# RFQ coupler review

S. Kazakov, O. Pronitchev, V. Poloubotko

05/21/2013

## Maximum electric field at coupler surfaces

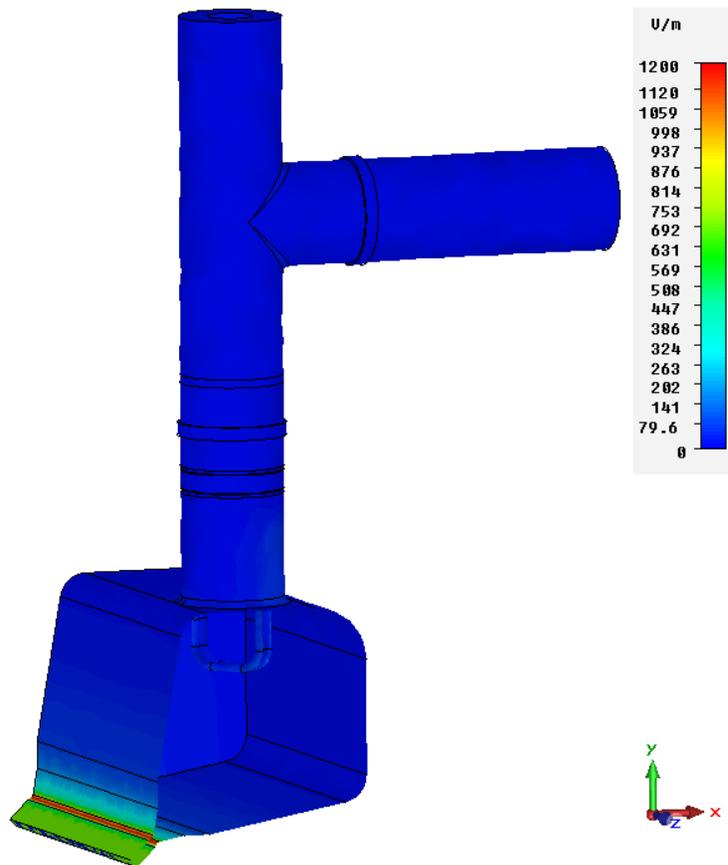
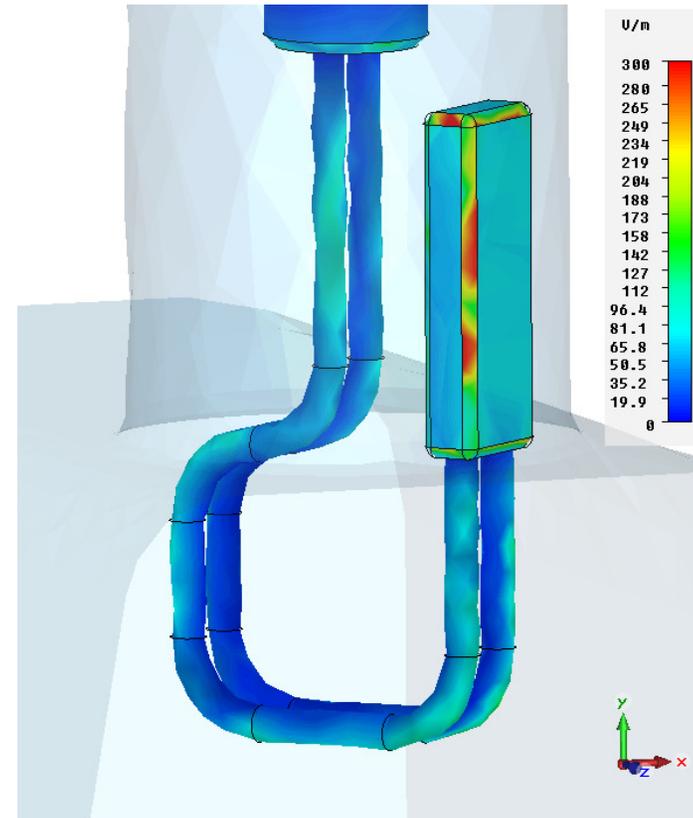
TKx16

Filed at loop 4 times less then field at vane,  
Should be no breakdown in the coupler.

## Sensitivity to loop sizes

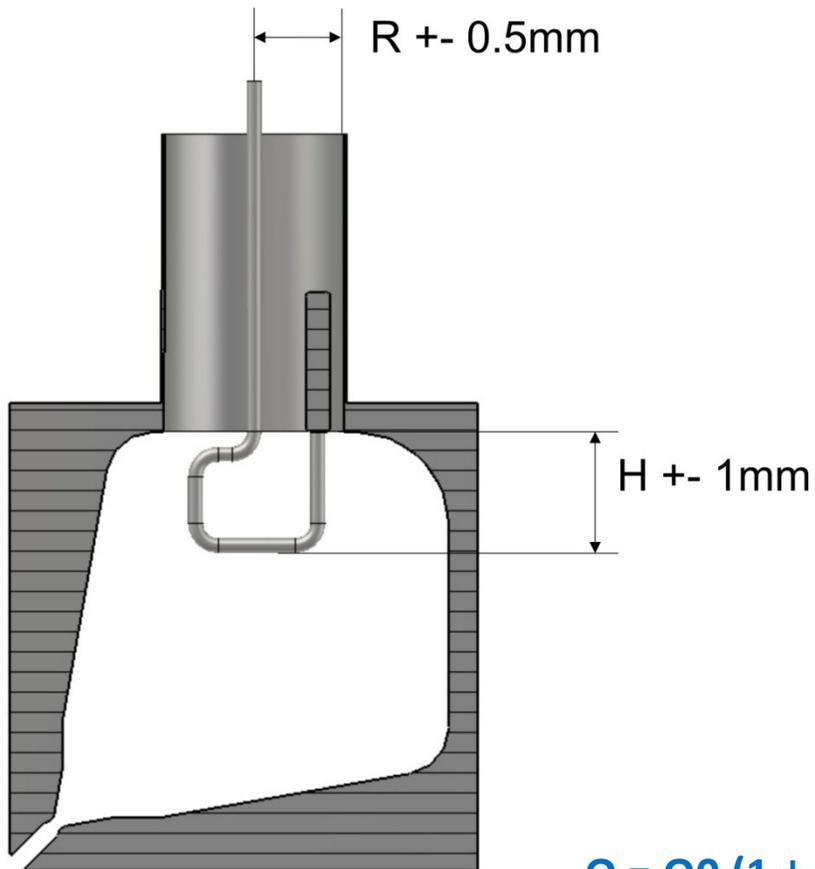
**TKx19** Large nonlinearity. Better to add more points.  
Timergali Khabiboulline x4693 13342N, 5/20/2013

**TKx110** Here also large nonlinearity. Better to check the reason  
Timergali Khabiboulline x4693 13342N, 5/20/2013

### Temperature along ceramic

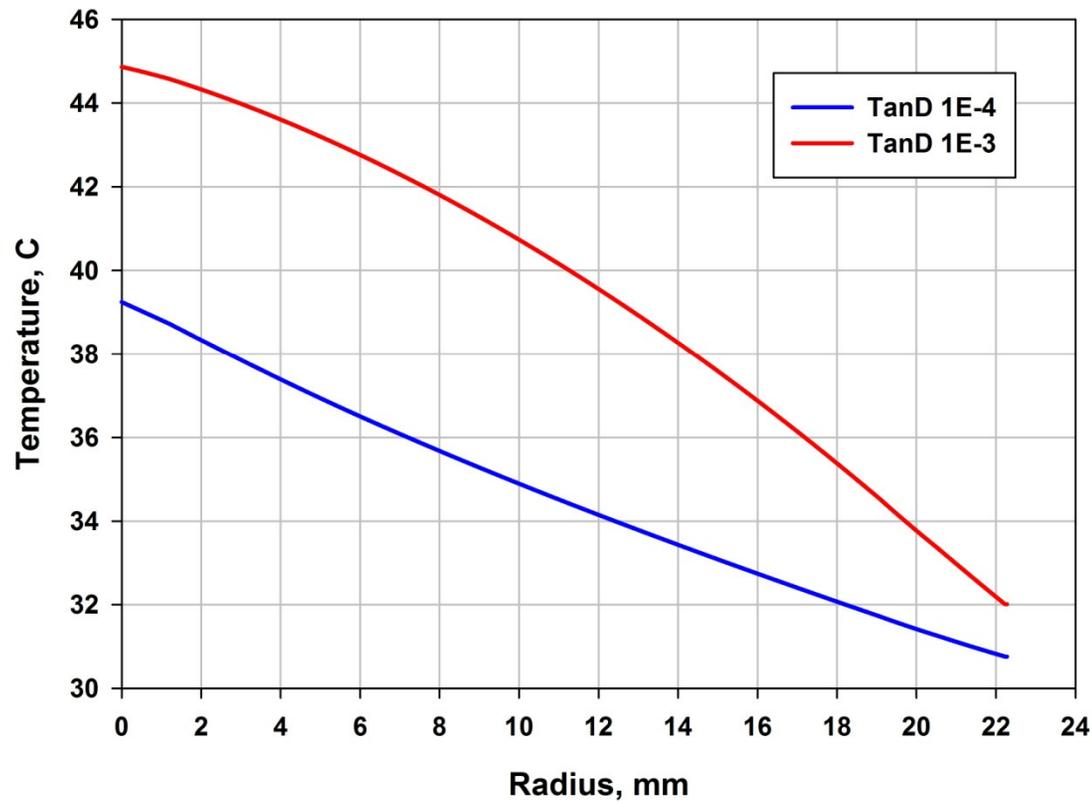
TKx114

Show examples of safe operation with higher gradients from existing couplers

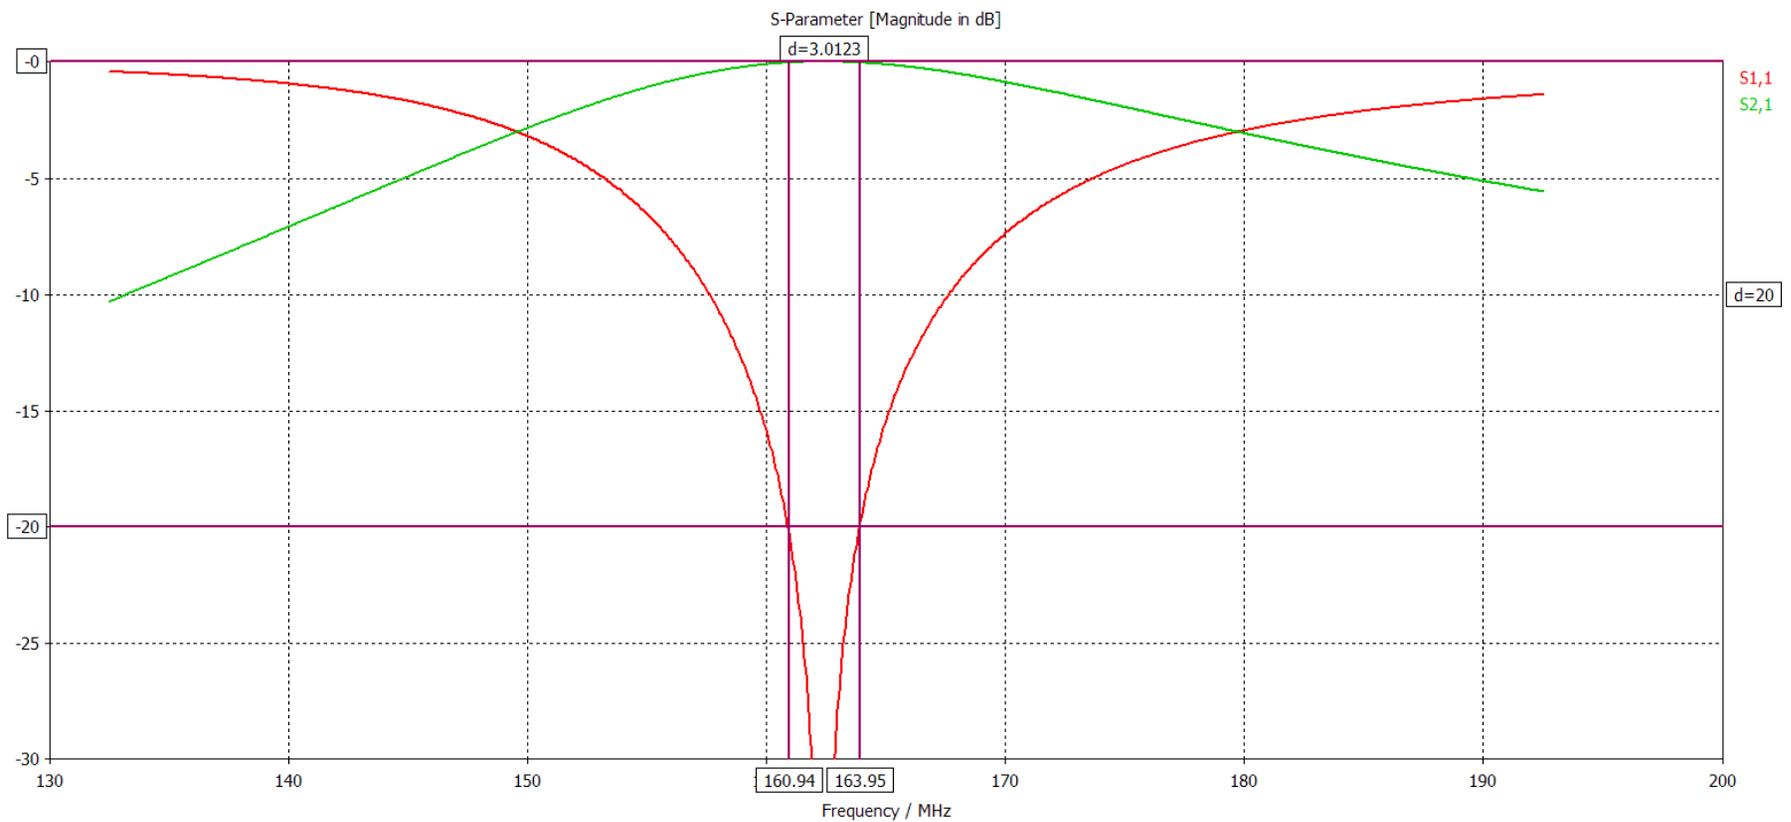
Resonant frequency will be adjusted by changing capacitive gap. TKx117

**Which gap? Between loops?**

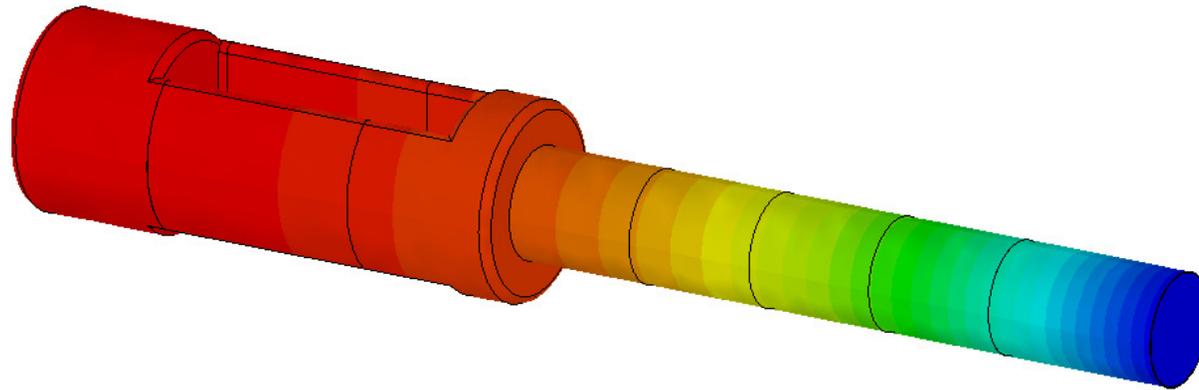
Temperature rise estimation.  $P \sim 232\text{W}$ . TKx118

What is transmitted power? 80 kW?
